Re: VAI Response to Traffic Engineering Peer Review
Town Yard Redevelopment
Andover, Massachusetts

Vanasse & Associates, Inc. (VAI) is responding to comments that were raised in the January 25, 2024 *Traffic Engineering Peer Review* letter prepared by The Engineering Corp (TEC) concerning their review of the November 9, 2023 *Transportation Impact Analysis* report that was been prepared by VAI in support of the proposed town yard redevelopment to be located in Andover, Massachusetts (hereafter referred to as the “Project”). Listed below are the comments that were identified by TEC in the subject letter that pertain to the November 9, 2023 report and require a response, followed by our response on behalf of the Project proponent.

Figure D.4 Resident Work/School Trip Transit Mode Share vs. Heavy Rail Transit Proximity for Non-CBD Residential Sites

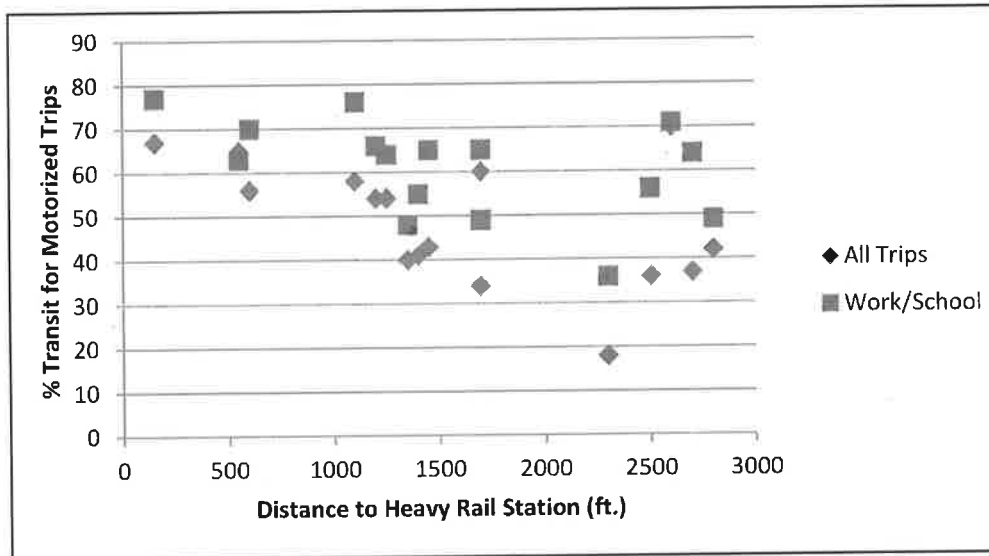
In Table 4 of the TIA, the mode split by land use has been provided. The Appendix includes a table showing the derivation of these mode splits based on area census percentages; however, no details of the derivation of the results have been provided for review. TEC is unable to determine their validity.

The Applicant should provide a more detailed step-by-step breakdown of both internal capture, person trips, and mode share credits, as well as documentation to the justification of each credit value. This includes looking into the trip generation calculation results shown in Table 5, which effectively shows that the coffee shop, almost exclusively used by the residents, as the primary use in the AM and an extensive use throughout the day. For instance, the 'walk' and 'other' mode share for coffee shop are 30% while they are only 13% and 21%, respectively for residential land use. If the credits applied forces the resulting 'residential' trip levels down in favor of coffee shop, the higher mode split credits for coffee shop as compared to residential result in less overall trips projected; even when the residential units are the primary use.

With regard to the mode split for the residences, the existing census data for the census tract the site is located in likely does not reflect the same proximity of the residences to the commuter rail station as is the case with this Project. Accordingly, this data was revised and adjusted to account for an increased public transit usage, and reduced auto usage. Additional justification for this change is shown in data from ITE related to Transit-Friendly Site Mode Share data, which indicated percentage of transit for motorized trips could be between 62 and 78 percent for work/school based trips and between 56 and 68 percent for all trips for sites within 600 feet of a heavy (commuter)

rail facility. This is shown in the Appendix to this letter, Figure D.4 from the ITE Trip Generation Handbook³.

Figure SD-1
Sight Distance Plan
Pearson Street at Site Driveway

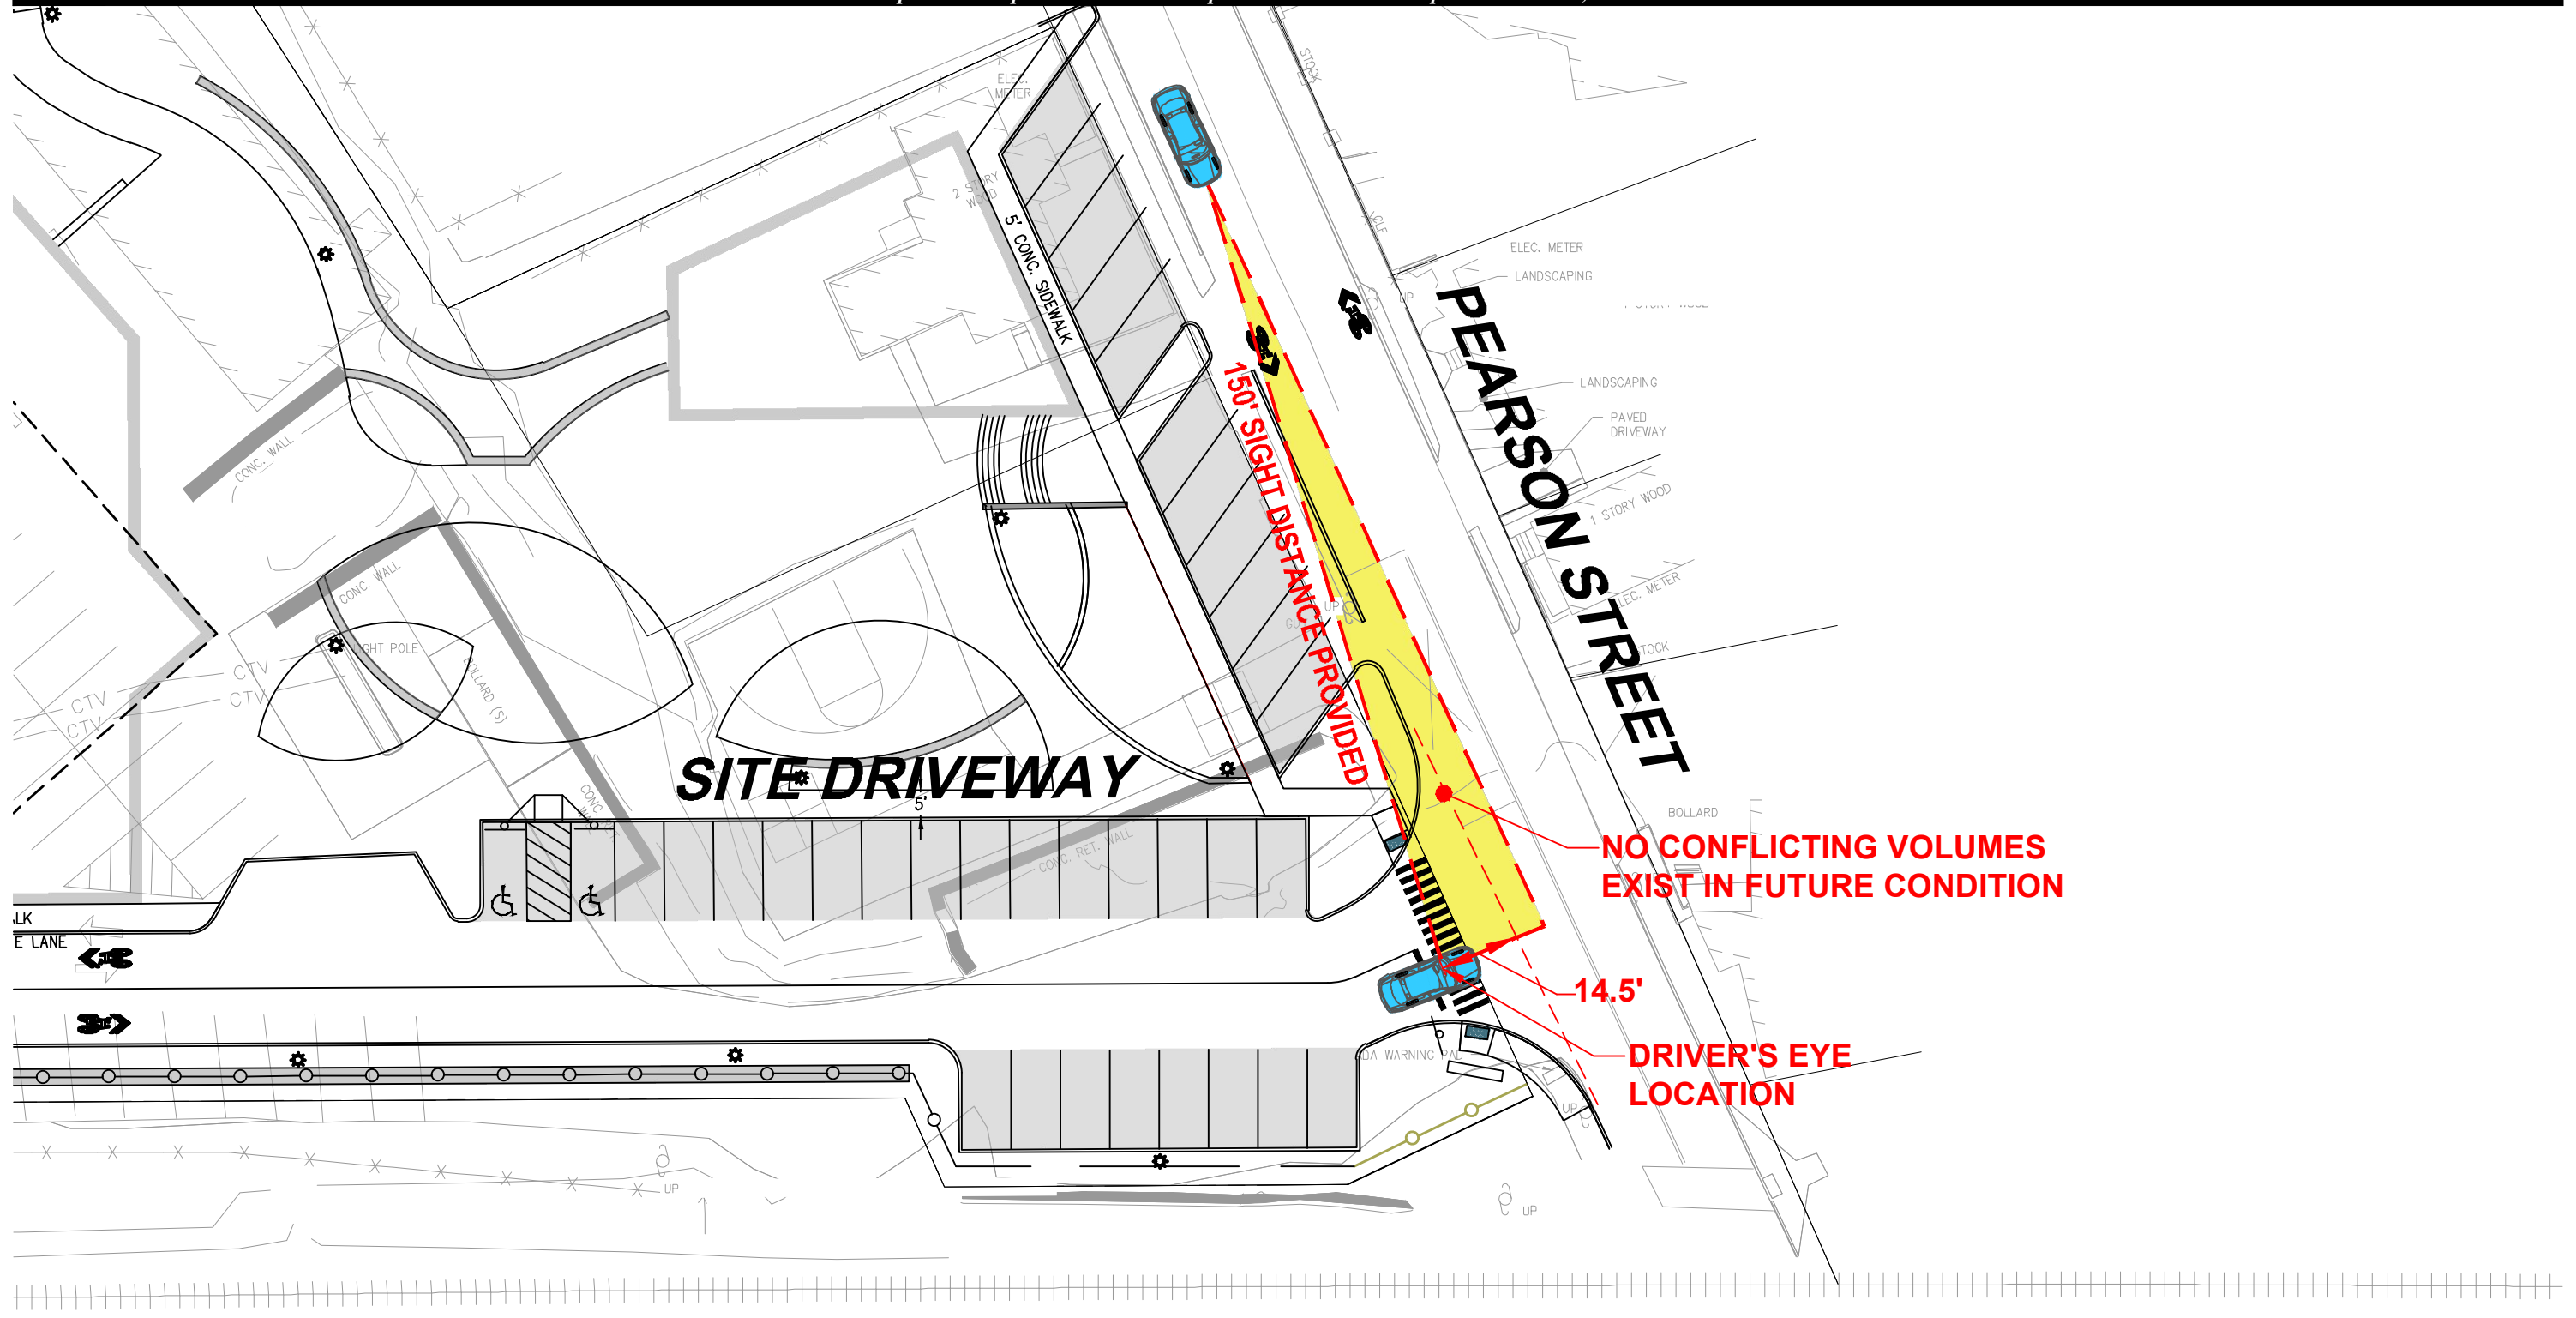
Comment 13: *The Applicant has provided stopping sight distance (SSD) and intersection sight distance (ISD) measurements for the Site Driveway along Pearson Street. The results are shown in Table 8 of the TIA and have been compared to recommended values obtained from A Policy on Geometric Design of Highways and Streets, 7th Edition, American Association of State Highway and Transportation Officials (AASHTO), 2018. The measured distances have been shown in the TIA to exceed these values, except for the ISD for vehicles looking west while exiting the site (111 feet). However, Table 8 contains notes stating that three of the four measured distances have been determined if parked cars to the east were removed and if a hedge to the west were cut. The fourth measured distance of 241 feet (SSD approaching from the west) is questionable since Pearson Street is roughly 100 feet from its intersection with Essex Street to the site driveway. A distance of 241 feet could only be attained by measuring further west along Essex Street, which places the limit about 150 feet from the railroad tracks. At this point, the sight distance is further affected by a concrete retaining wall in the parking area of Ann's Cleaners at #2 Railroad Street, as well as a railroad signal gate and utility poles on Pearson Street near the proposed site driveway. The Applicant should provide a graphical depiction, preferably in the form of a sight triangle sheet in the site plans, of the sight lines for this driveway. Sight lines to the east along Pearson Street should not cross over the head-in parking stalls proposed along the northerly side of the roadway.*

VAI Response: The sight distance graphic for this intersection (SD-1) is included in the Appendix to this letter and in the updated TIA.

DRAWING NUMBER:
C4.2

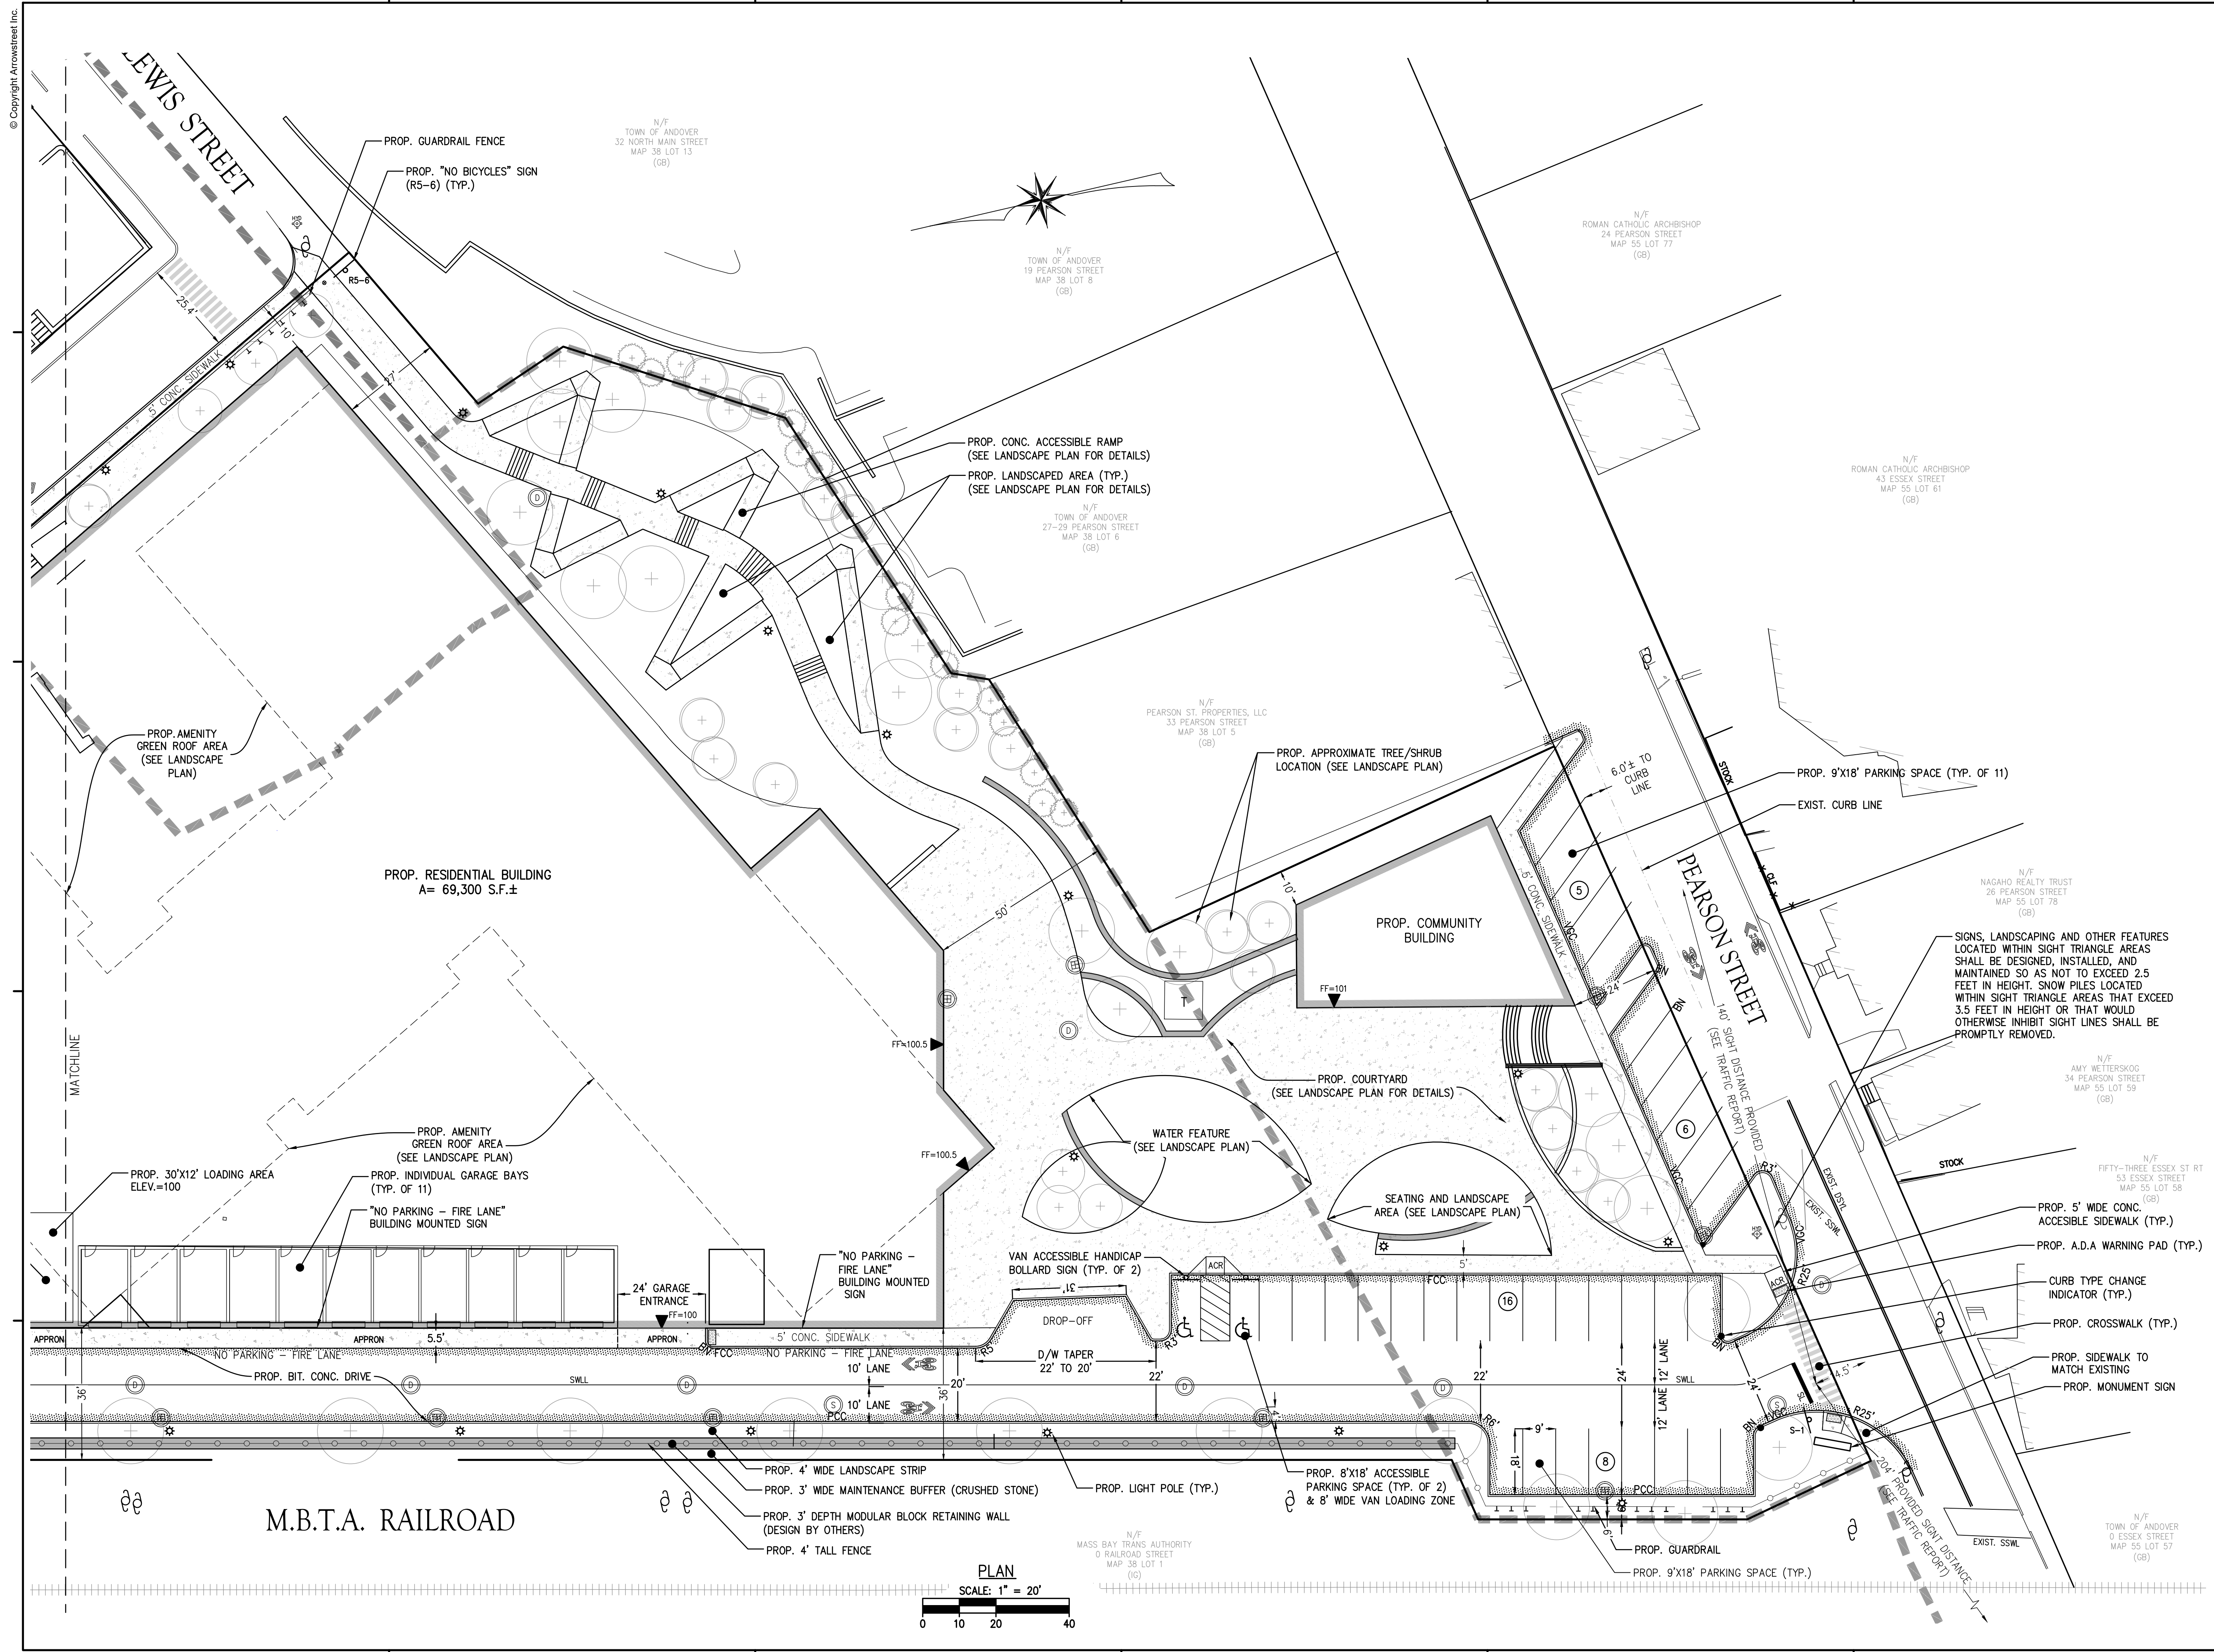
VAI Response: The indicated pedestrian crossing has been added to the Figure 2 which is included in the updated TIA.

VAI Response: No response required.

Comment 8: *MassDOT crash records were evaluated for the years 2016-2020, the latest available 5-year period of complete data and have been described in the TIA. Of the eight (8) study area intersections studied, three (3) were shown to have crash rates above 0.57 crashes per million entering vehicles (MEV) for unsignalized intersections (MassDOT District 4 rate). These intersections include Pearson Street / Lewis Street [Site Driveway] / Depot Pizza Parking Driveway (0.86 crashes per MEV), Essex Street / School Street (0.64 crashes per MEV), and Essex Street / Brook Street / Ridge Street (1.25 crashes per MEV). The TIA does not describe direct off-site mitigation by the Applicant to reduce these crash rates or directly address safety at these locations. Although off-site mitigation is further described in subsequent comments, the Applicant should work with the Town to evaluate and implement, at a minimum, short-term / low-cost safety improvement countermeasures at these key locations.*

MC Response: An updated sight triangle plan is provided as Sheet C4.2 provided to address this comment.

MC Response: The TIA reflected existing conditions sight distances while Sheet C4.2 reflected proposed conditions. However, due to changes noted previously, Plan Sheet C4.2 was updated.

MC Response: The parking area on Pearson Street has been updated to improve sight distance from the site driveway. This is shown in the appendix to this letter and revised Plan Sheet C4.2.
